## **APPROVED MINUTES OF THE MEETING**

**February 19, 2009**

Rose Street – Wolcott Ave. S  
Seattle Trade Center Skybridge over Elliott  
SR 519 Phase II Grade Separation  
University of Washington Light Rail Station

**Northerly view of the Light Rail Station Improvements**

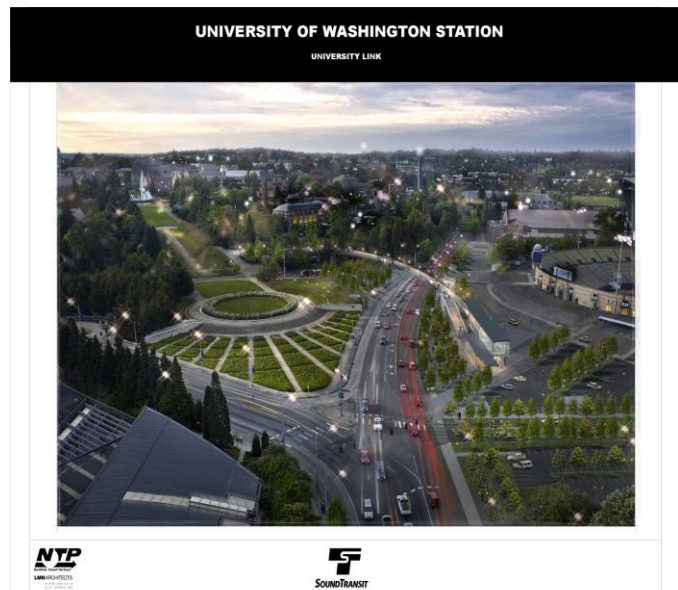
- Continue to strengthen the correspondence between the art and architecture of this project. The art component provides vibrant expressive qualities to the station experience, which can be reinforced by the materiality and colors of the architecture. Take another look at the relationship of the somber, somewhat heavy qualities of the architecture's colors and the art elements in the chamber structure. Wishes the art could have been manifested to the outside or that the architectural expression could have been more iconic and strong.

- The lightness qualities sought in the design of the head house are good objectives. The iconic qualities, signaling the locus of a significant transit exchange point, are important and vital design objectives. The large portal form, in the rendering, appears over powering and imposing. The vertical elements of the building's façade planes should read as more pronounced than the horizontal ones, although the rendering does not convey this.

- The bridge is achieving a good strong articulation of structure. Long term durability is an essential quality to be achieved in fabricating the elegant ribbon hand rail and other components. Design choices for this station rely on the minimally sized, high-quality, yet strong elements.

- Be attentive to what could be an over-reliance on the gray palette.
- The landscape design has advanced in strong and appropriate ways. The vista analysis work is admirable. The integration and extension of the qualities inherent in the different zones abutting the project is noteworthy. The choice of large-scale landscape materials in selected locations is a good one; it is essential to the success of this station design. The resolution of the parking lot - topographic form, edges and internal landscape qualities and continuity with related movement patterns - is skillful and noteworthy. Continue to seek sustainable practices consistent with serving the game-day functions of this space.

- The proposed green wall seems a bit alien. It comes across as a device to obscure or cover up which is in dramatic contrast to the overall sensitivity and integrated qualities of this landscape design.

- The diagonal allee of trees from the head house to the intersection holds good promise but take another look at the termination qualities of this design element. The large vent shafts, oval in plan, are significant elements. Continue to explore ways to reduce their visual impact. For example, the juncture of the plinth to the metal-clad shaft could hold potential for a distinct shadow line to lighten the form.
